Figure 5: -Site Plan showing the proposed traffic circulation off Gilmore Road through the site onto Bowen Place.

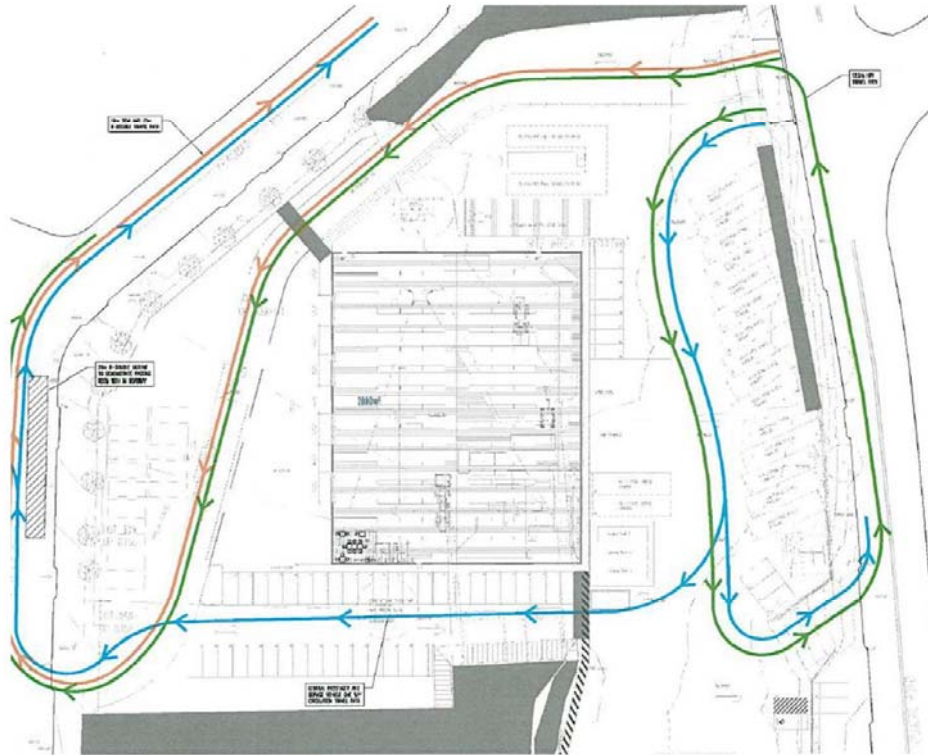
- Turning templates show a 12.5m large rigid vehicle would be unable to make the left turn from Kealman Road into Bowen Place at the same time as a 25m B-double was exiting Bowen Place. This should be addressed/ameliorated in future amendments;

- The turning paths on sheets C101 and C103 show the vehicle turning from the wrong side of Gilmore Road when entering the site. AUSTROADS turning templates indicate the vehicles appear to be able to enter the driveway from the correct side of the road. This should be confirmed with lodgement of amended turning path plans;

- RMS notes that the kerb return at the junction of Kealman Road and Bowen Place has been extended to prevent larger vehicles from making the left turn from Bowen place into Kealman Road. Investigations into the other properties that access from Bowen Place should be consulted to ensure that this proposed change will not affect their truck movements; and

5. The applicant has proposed that all traffic enter Canberra Avenue via the signalised intersection on Gilmore Road. Council needed to be satisfied that no truck could turn left out of Bowen Place and that the adjoining land holder would support the proposal as this would affect their business (Monaro Mix Concrete). The applicant was able to provide written support from the adjoining business owner and made provision for engineering works to extend the kerb in Bowen Place to inhibit trucks to turn left and use the Kealman Road and Canberra Road intersection. Council also considers that a median in Kealman Road needs to be constructed to stop trucks mounting the kerb extension.

2. 25m B-doubles partly blocked Bowen Place when turning out of the site. A revised template was used meeting Austroads and satisfied the issue of the trailer location when halted at the intersection.

3. Site manoeuvrability was brought into question to ensure that all articulated vehicles could manoeuvre on site. The turning templates revised and supplied show adequate manoeuvrability on site.

4. The applicant was asked to show that a truck turning right out of Bowen Place did not compromise the stopping sight distance of traffic travelling towards Canberra Avenue along Kealman Road. The calculations provided by the applicant displayed that the intersection has adequate sight distance.

The applicant was able to provide written support from the adjoining business owner and allow for engineering works to extend the kerb in Bowen Place to inhibit trucks turning left and using the Kealman Road and Canberra Road intersection. Council further to this consider that a median in Kealman Road needs to be constructed to stop trucks mounting the kerb extension. Should approval be granted appropriate conditions will need to be applied.

Figure 6: Location of Additional Potential Sensitive Receivers

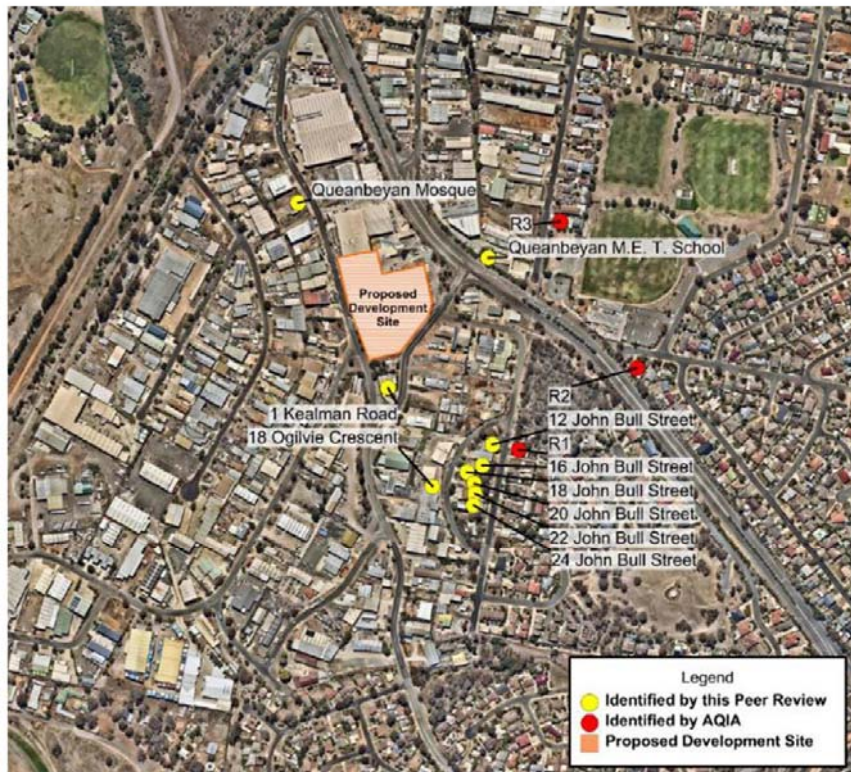
It is noted that additional receptors are located in the area zoned for industrial activity. These are all recognised by Council as approved premises.

The additional premises identified include the following premises shown in Figure 6 below:

The applicant's consultant has nominated use of Section 2.2.1 of the NSW Industrial Noise Policy which recommends that the industrial amenity criteria are applied to isolated residences within an industrial zone.
